Letter Report

**INEL EVALUATION OF THE BOILING WATER REACTOR
OWNER'S GROUP NEDC-32160P TOPICAL REPORT
"CALIBRATION INTERVAL EXTENSION"**

May 29, 1996

Prepared for the
Office of Nuclear Reactor Regulation
U.S. Nuclear Regulatory Commission
Washington, DC 20555
Under DOE Idaho Operations Office
Contract No. DE-ACO7-94ID13223
JCN L1695, Task 14, TAC No. M-85776

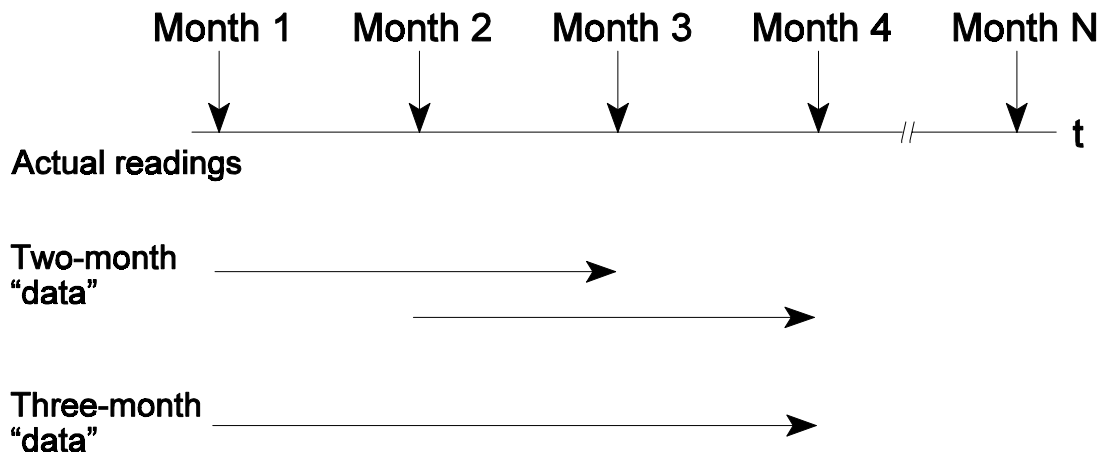
And lastly, an important concern with the overall BWROG data analysis methodology is that short time interval data (e.g., one , three, or 18-month intervals) are used to come up with pseudo-time intervals of one to 48 months. For example, if data for four one-month time intervals were available, the BWROG data analysis program would generate three one-month data points (a data point is the difference between two instrument readings), two two-month data points (first month to third month and second month to fourth month), and one three-month data

point (first month to fourth month). The figure below illustrates this data analysis concept. What is disturbing about this analysis approach is that two and three month data really do not exist. During the time from the first month to the fourth month, the instrument could have been adjusted, recalibrated, cleaned, lubricated, jolted, etc. Any of these impacts to the instrument could alter, possibly subtly, the operation of the instrument over time. Consequently, the differences in data readings from month one to month four are not the same for a component setting untouched for four months compared to a component “impacted” three times during the four months. The fact the data encompasses overlapping time intervals will complicate the

analysis. This complication has not been evaluated by the BWROG. Since the overlapping time interval data causes one set of interval “data” to be dependent on another set (i.e., a single set of data is used to synthesize the spectrum of data from one to 48 months), it is suspected that the overall data analysis results are flawed.

Figure 1. OISD 95% confidence intervals plotted for component CR2820.

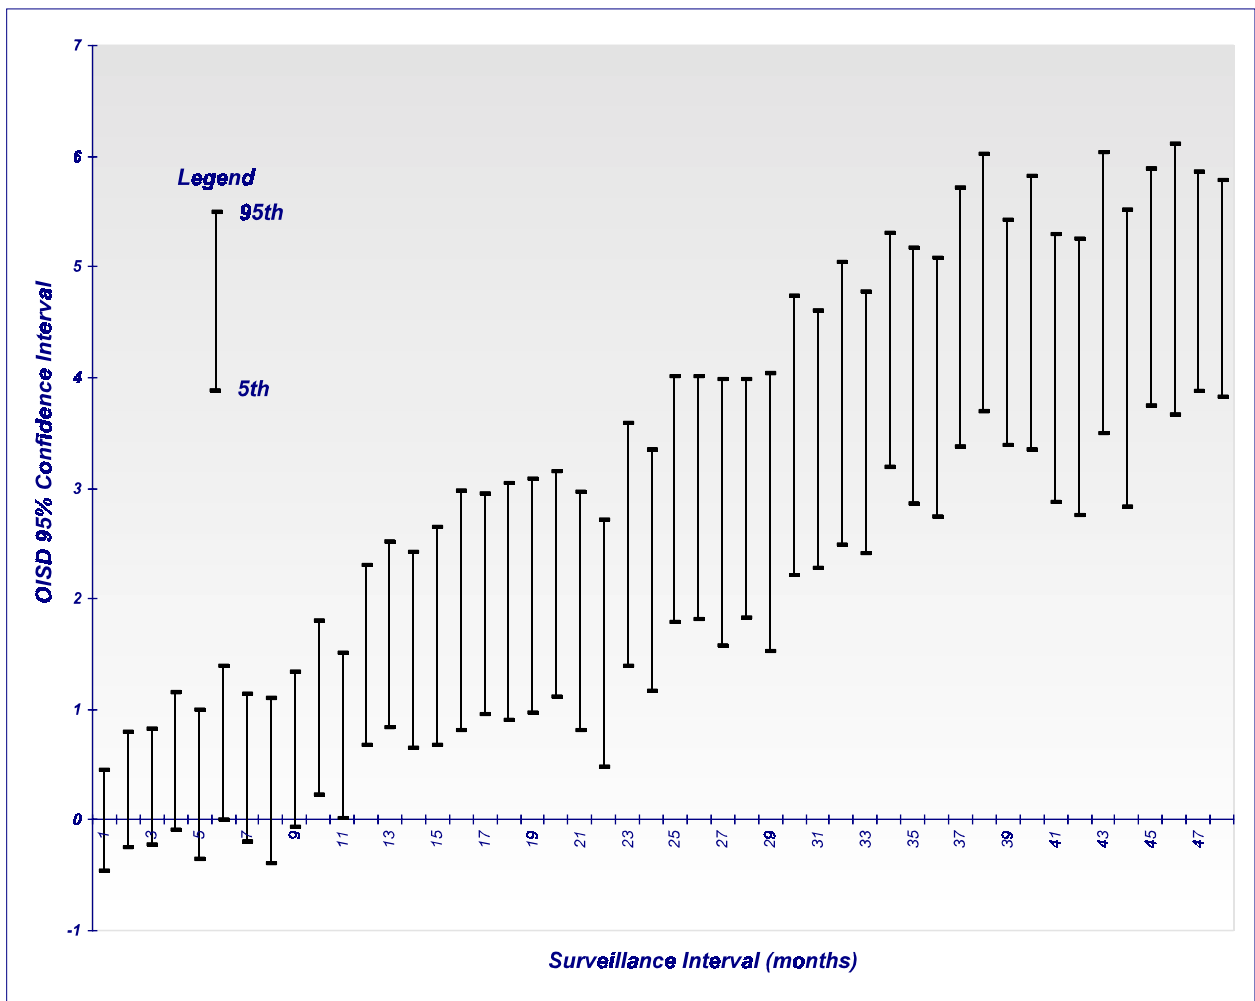
The INEL performed this statistical test on two BWROG example data handouts. The results show that *most* of the confidence intervals for the calibration intervals *did not* contain zero as a point in the interval. The results of the confidence interval calculation are shown in Tables 1 and 2. Figure 1 shows a plot of the confidence intervals for component CR2820 and clearly shows the OISD confidence intervals increasing in height over time and do not encompass zero. The BWROG data analysis should provide this type of figure as part of the data analysis to assist reviewers in visualizing data trends.
